BOARD OF WATER SUPPLY

Subject: Navy testimony regarding Senate Concurrent Resolution 35, March 20, 2019, by Captain M.K. Delao and the Navy's Destructive Testing Report

The Honolulu Board of Water Supply (BWS) offers the following comments regarding the Navy's recent testimony (copy enclosed for reference) regarding Senate Concurrent Resolution 35, March 20, 2019 [Navy, 2019, March 20] and a Navy press release [Navy, 2019 February 25] as well as comments regarding the Navy's destructive testing report [Navy, 2018, December 17].

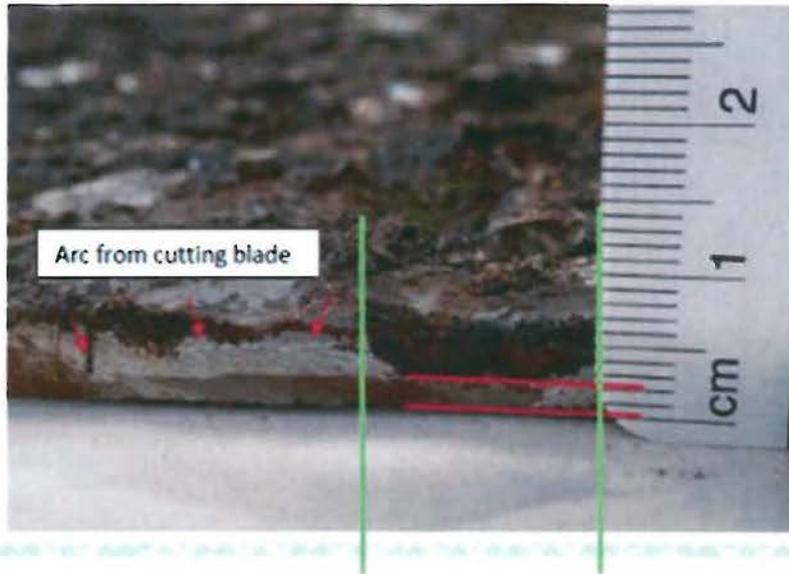
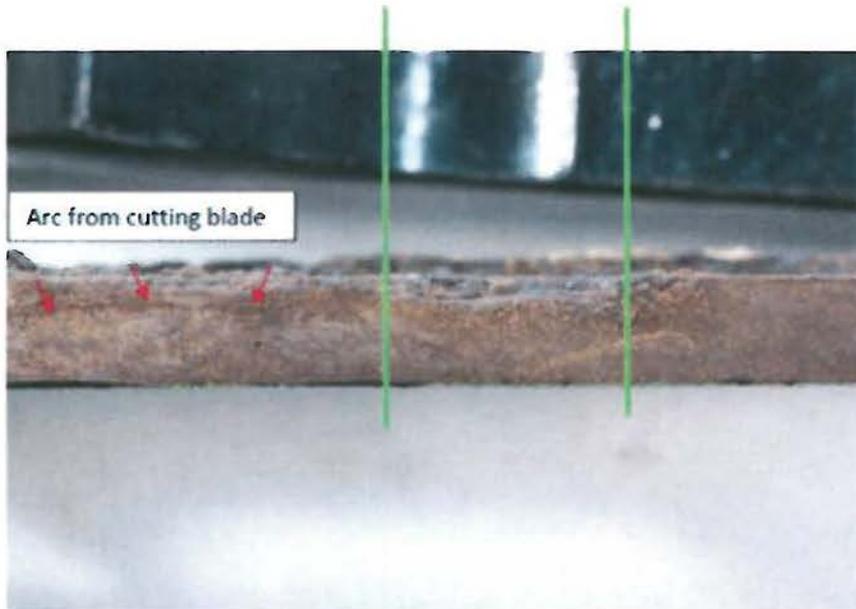
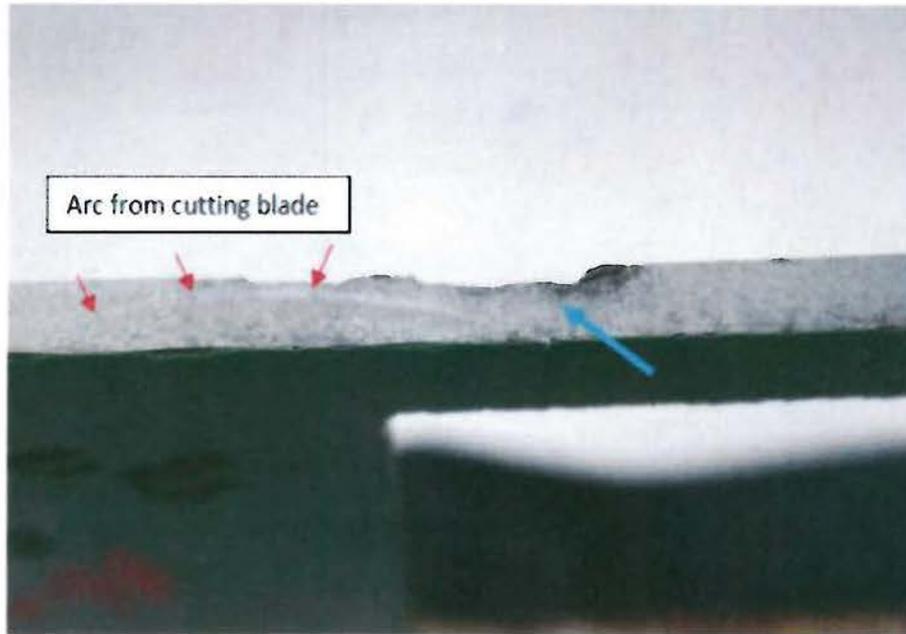
The Navy then states that "...the non-Navy photo (with the ruler, Figure 1) which was used to allege that corrosion of this coupon was worse than the Navy anticipated. Also included are two laboratory photos (Figures 2 and 3) of the same coupon which show, after proper preparation and precise measurements, significant metal thickness remains in this area." The figures refer to Coupon #7. First, BWS was not allowed to handle or otherwise participate in the NDE or destructive testing or to otherwise properly prepare or make more precise measurements, and secondly, this is just one of the 10 coupons examined. For instance, if the Navy had selected Coupon #3 to discuss; the results would be dramatically different. The Navy's NDE indicated that the expected minimum thickness on this coupon would be greater than 0.200 inches as PAUT found no indication (Appendix B). BWS's edge measurements estimated that the edge thickness was 0.157 inch. The destructive testing report showed that the actual minimum thickness on the specimen was 0.132-inch. The figure below shows the cross-section through Coupon #3 at the thinnest location. For reference, 5.5 mm is 0.217 inches, 3.34 mm is 0.1315 inch and a 1/4-inch is 6.35 mm. As can clearly be seen the smallest defect is significantly smaller than the Navy expectation from PAUT of the thickness being greater than 0.200 inch.

In this specific instance, the BWS edge estimate, based only on the crude measurements allowed by the Navy, were significantly closer to the actual plate minimum thickness. For Coupon #7 it is true that “the corrosion was far worse than the Navy expected.”

Finally, with respect to Coupon #7, BWS is not convinced that the minimum thickness of the edge is what is stated and will remain unconvinced until the Navy provides the CT scans and allows an independent inspection of the cut plates and metallographic samples. BWS has made this request in our March letter [Lau, 2019, March 6].
